Access Compliance Report

Public Rights-of-Way

Intersection ID: 9934	Main Street: N_PINE_ST	Cross Street: W_26TH_ST	Location: N
ADA ID: E1D04C8AC0EA	Ramp Type: BlendTrans2	Initial Pass/Fail: Pass	Overall Compliance: No
			Severity Score: 17.75

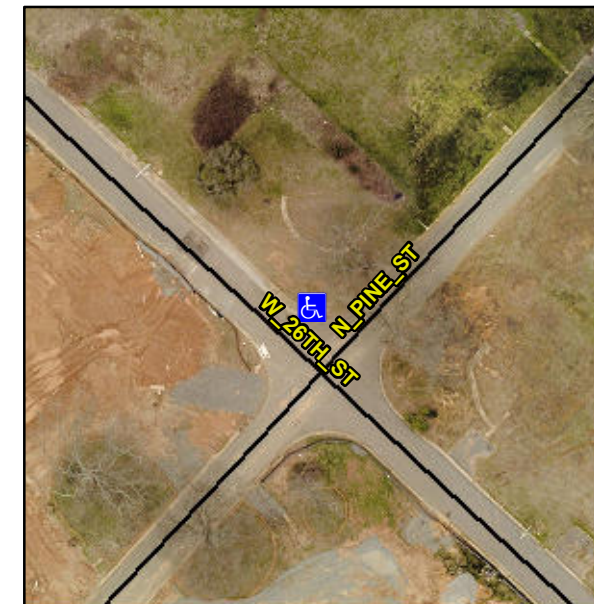
VEGETATION OVERGROWTH, NO RT SW

Not Found, R304.5.3, R305.1.4, R305.2, R302.7, R302.7.2

Remove & Replace Curb Ramp With Two New Directional Ramps or Equivalent. Remove & Replace Gutter.
